APPLICATION NO.	FILING DATE	FIRST NAMED INVENTOR	ATTORNEY DOCKET NO.	CONFIRMATION NO.
10/719,863	11/19/2003	Bruce Reid Lee		1514

Office Action Summary

This is an office action for serial number 10/719,863, entitled Scuba Tank Mounting Brackets, in response to Amendments filed on March 9, 2005 and November 1, 2004.

FIG. 1

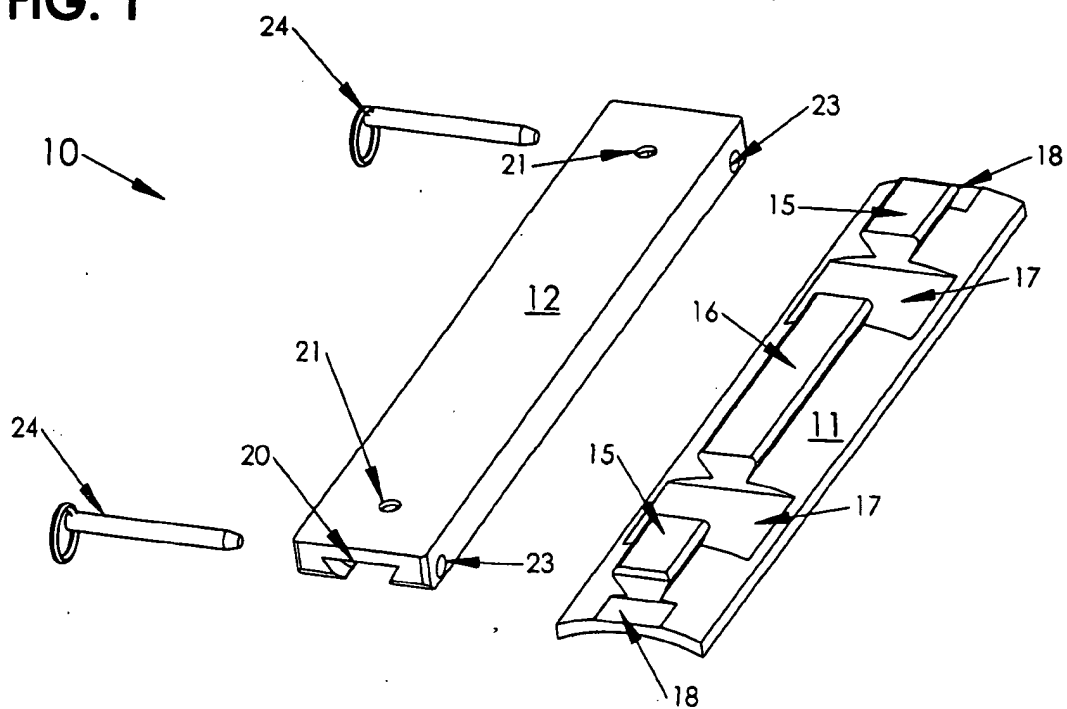
The substitute specification filed November 1, 2004 has not been entered because it does not conform to 37 CFR 1.125(b) and (c) because: It does not include a marked up copy of the substitute specification; it introduces new matter consisting of the slots (17) recessed below the face of the bracket and the nuts for screws.

The drawings were received on November 1, 2004. These drawings are disapproved.

disapproved kw 5/31/05

In addition to Replacement Sheets containing the corrected drawing figure(s), applicant is required to submit a marked-up copy of each Replacement Sheet including annotations indicating the changes made to the previous version. The marked-up copy must be clearly labeled as "Annotated Sheets" and must be presented in the amendment or remarks section that explains the change(s) to the drawings. See 37 CFR 1.121(d)(1). Failure to timely submit the proposed drawing and marked-up copy will result in the abandonment of the application. The Replacement Sheet must be clearly labeled as "Replacement Sheet".
